SERVICE BULLETIN

NACELLE – INLET COWL – TAI INTERBULKHEAD DUCT AND ACCESS PANEL –
REPLACEMENT OF

December 10, 1997
Revision 1 - September 08, 1999

V2500-NAC-71-0184

REPLACEMENT OF TAI ACCESS PANEL AND OUTER DUCT
FIGURE 1 SHEET 1 OF 3

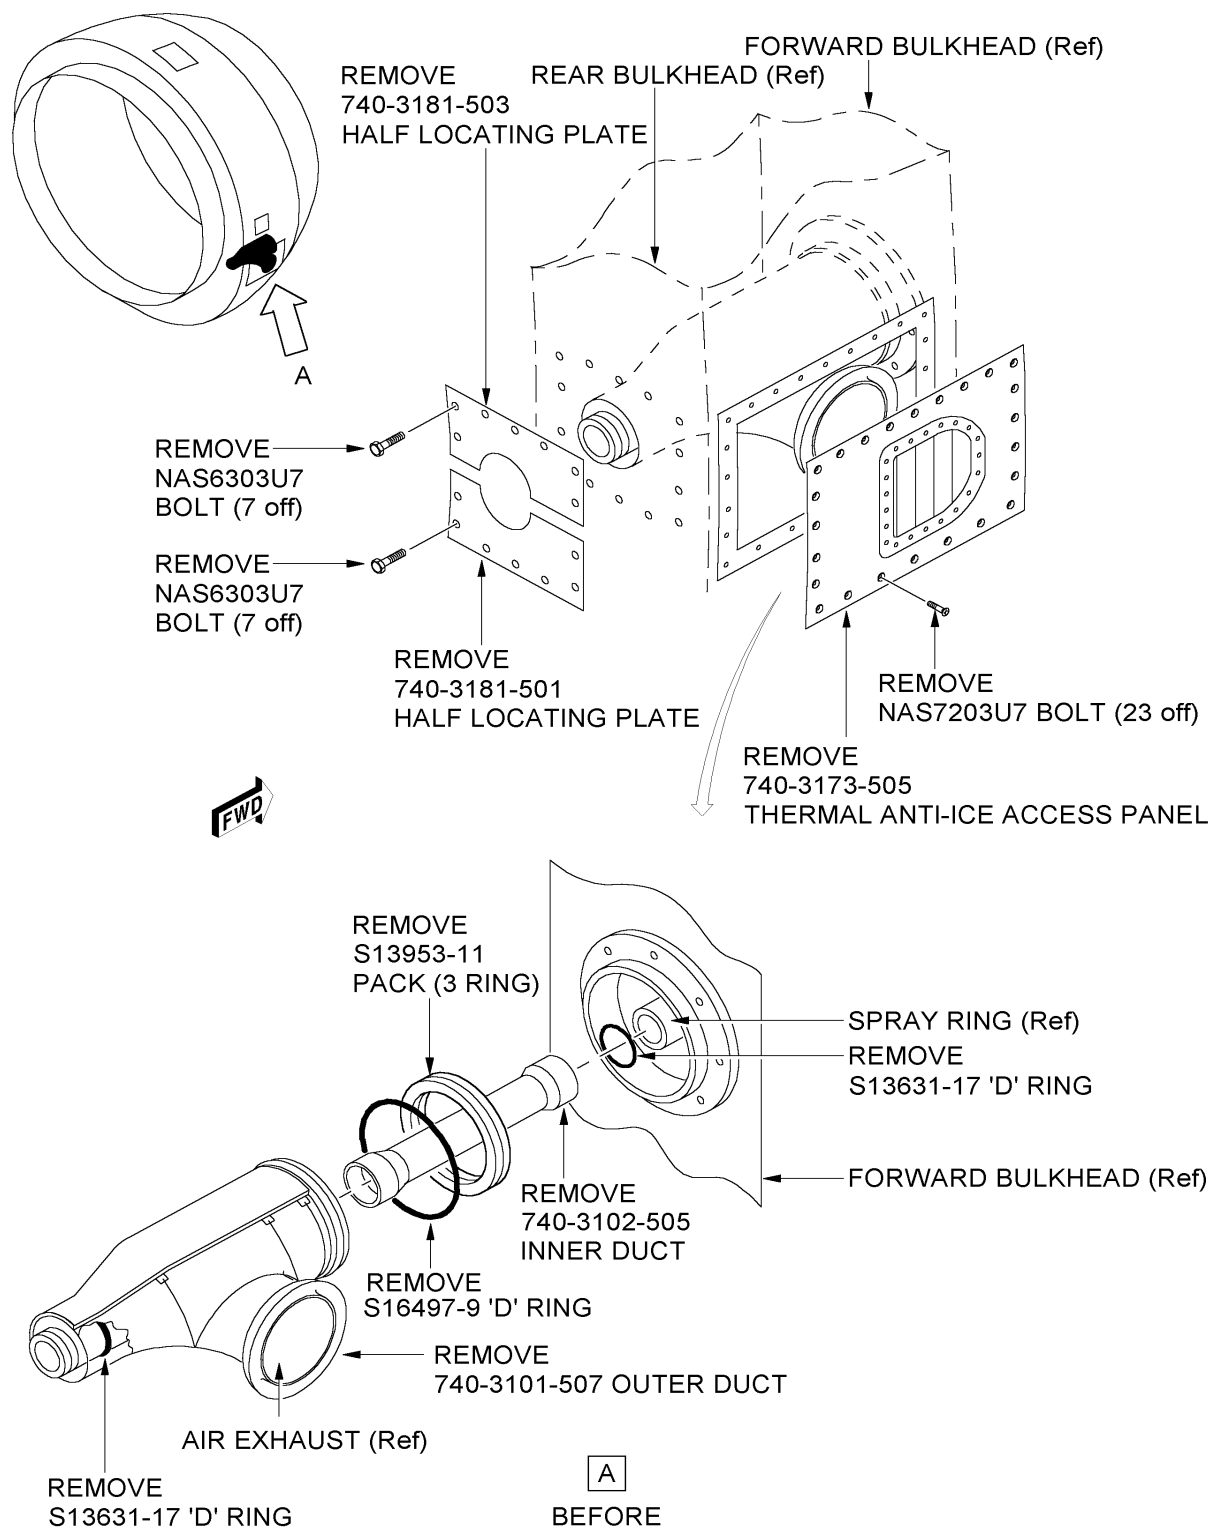
- (1) Remove 23 off NAS7203U7 bolts to release the 740-3173-505 TAI access panel. Refer to Figure 1 Sheet 1.
- (2) Remove 7 off NAS6303U7 bolts to release the 740-3181-503 half-locating plate. Remove the half-locating plate.
- (3) Remove 7 off NAS6303U7 bolts to release the 740-3181-501 half-locating plate. Remove the half-locating plate.
- (4) Put your hand into the air exhaust and hold the 740-3102-505 inner duct. Pull the inner/outer duct assembly away from the spray ring and remove from the inlet cowl. Discard the S13631-17 “D”-ring and put a blanking cap on the spray ring.

- (5) Cut the lockwire and remove the 1-07597-00-00 TAI outer duct insulation from the inner/outer duct assembly. Refer to Figure 1 Sheet 3.
- (6) Pull the 740-3102-505 inner duct away from the 740-3101-507 outer duct. Discard the 740-3101-507 outer duct, S13631-17 “D”ring, S16497-9 “D” ring and S13953-11 pack (3 ring). Refer to Figure 1 Sheet 1.

REPLACEMENT OF TAI ACCESS PANEL AND OUTER DUCT
FIGURE 1 SHEET 2 OF 3.

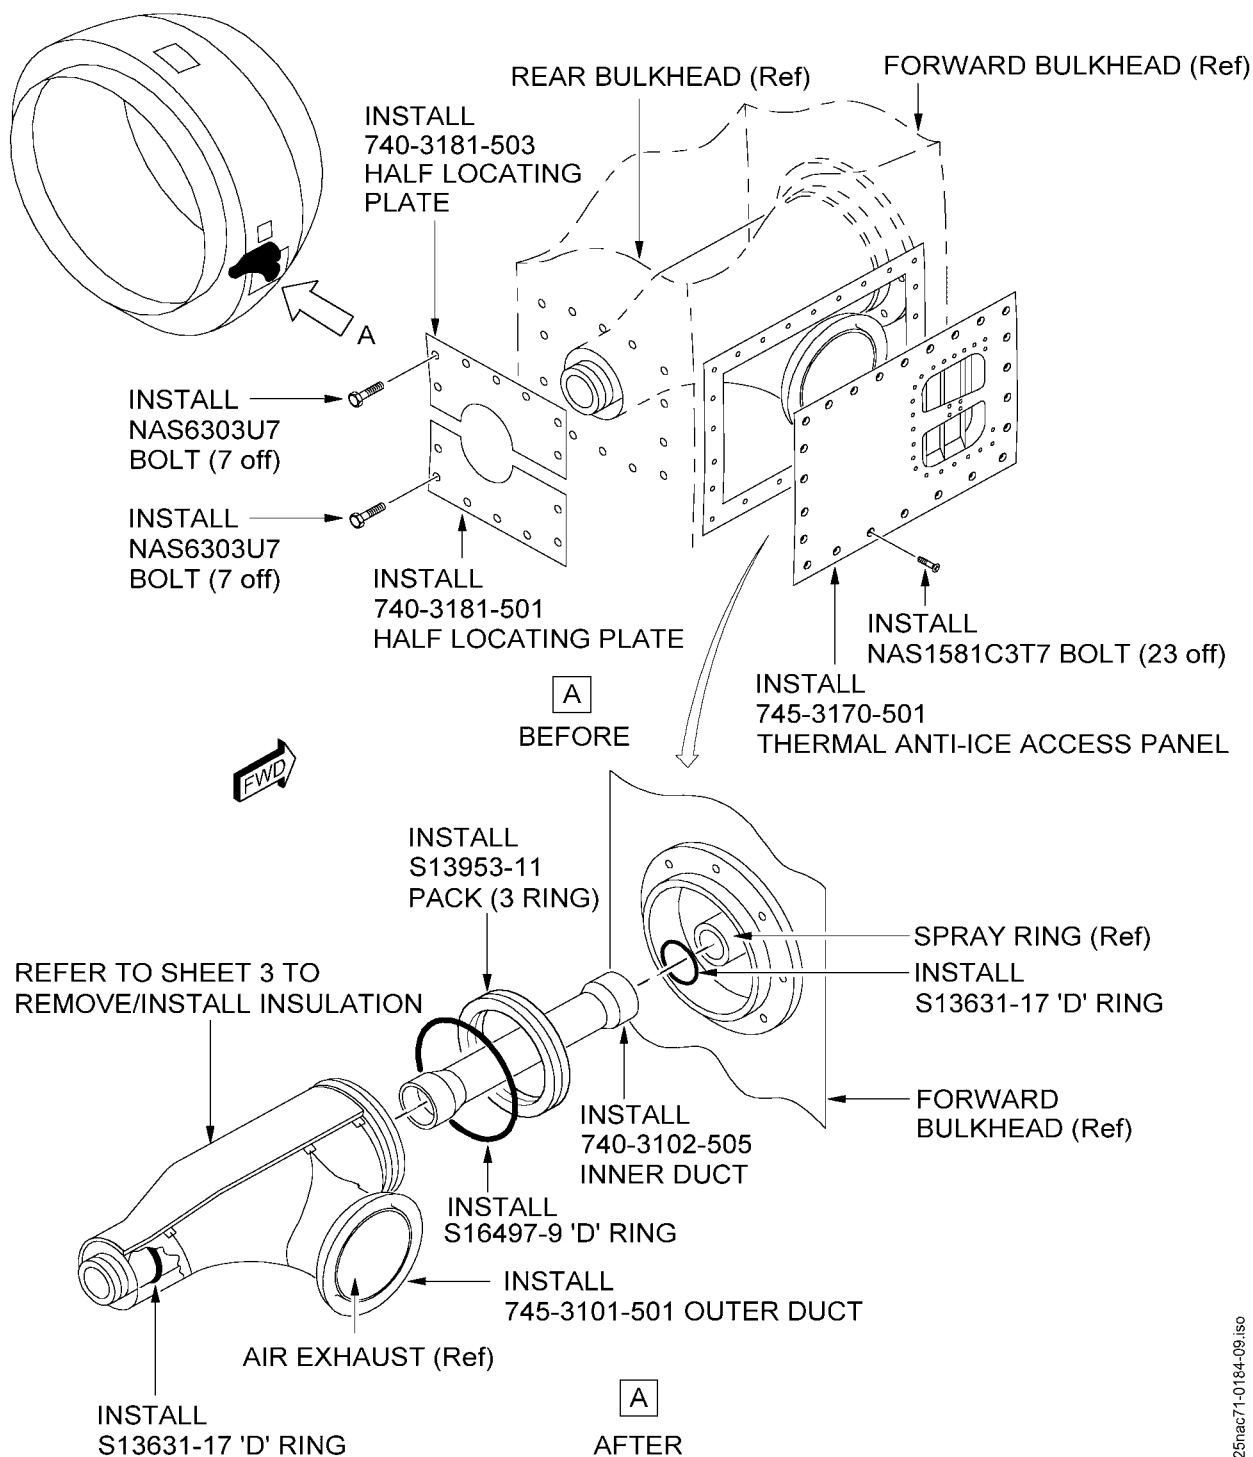
- (7) Remove the blanking cap from the spray ring and install a new S13631-17 “D” ring as shown. Refer to Figure 1 Sheet 2.
- (8) Install a new S13631-17 “D” ring to the aft end of the new 745-3101-501 Outer Duct as shown. Install a new S16497-9 “D”ring and a new S13953-11 pack (3 ring) to the forward end of the new 745-3101-501 Outer Duct .

REMOVAL/INSTALLATION OF DUCT INSULATION
FIGURE 1 SHEET 3 OF 3

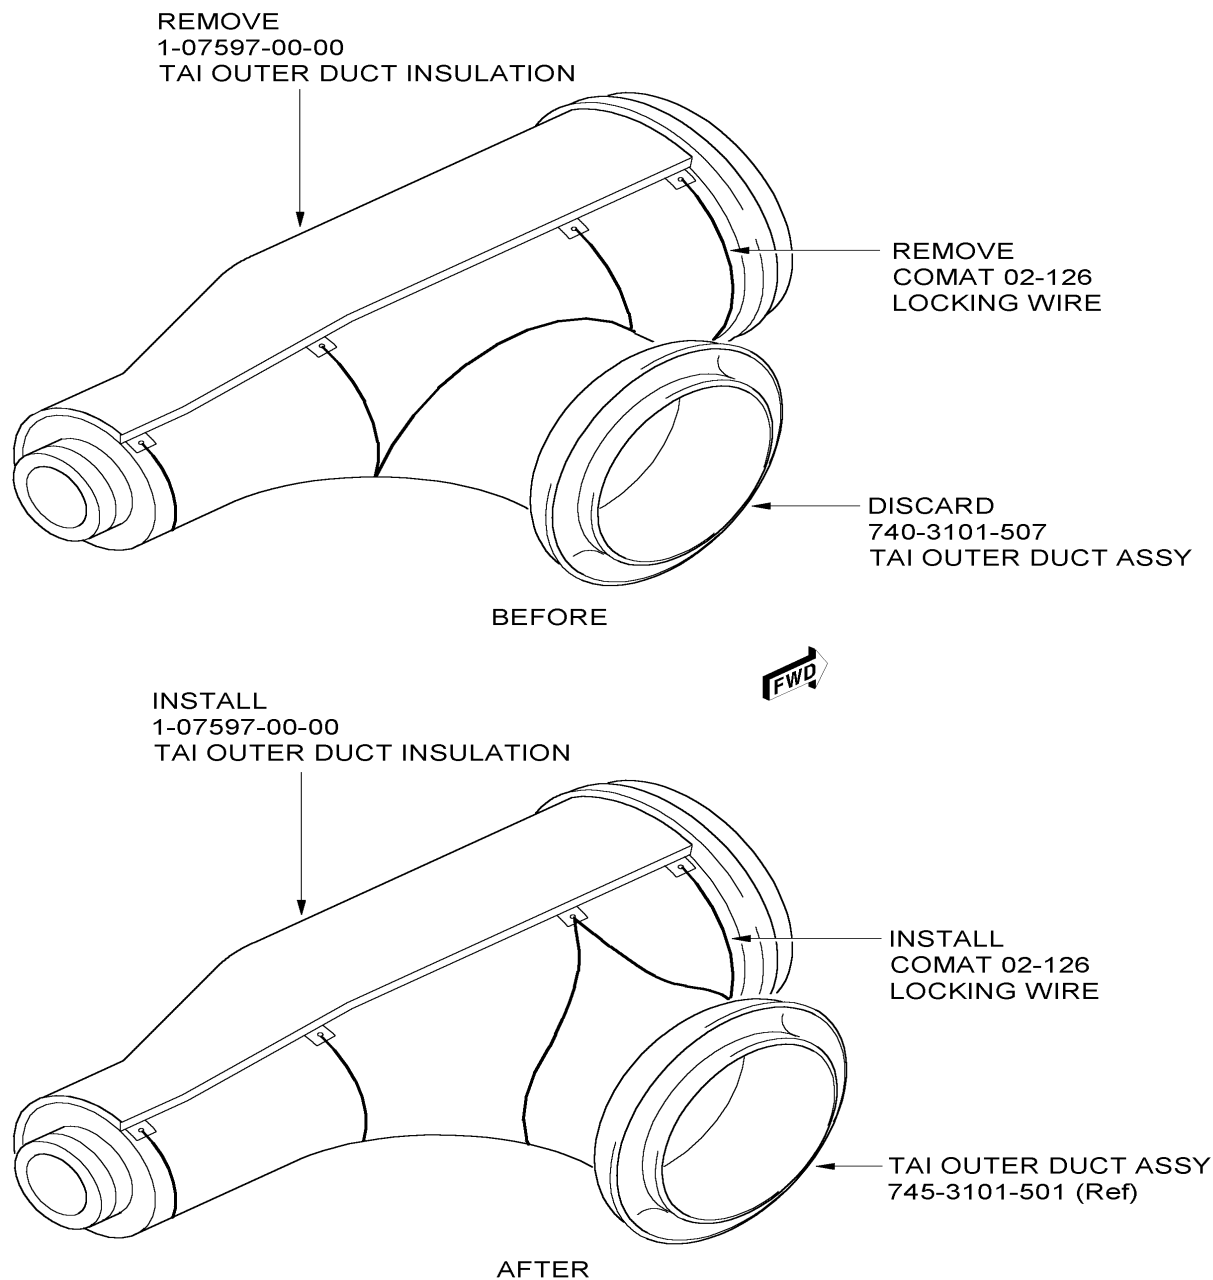
- (9) Put the 740-3102-505 Inner Duct into the new 745-3101-501 Outer Duct. Make sure the Inner Duct engages on the aft “D”ring.
- (10) Install the 1-07597-00-00 Insulation on the new 745-3101-501 Outer Duct and secure as shown with lockwire (CoMat 02-126). (Refer to figure 1, Sheet 3).
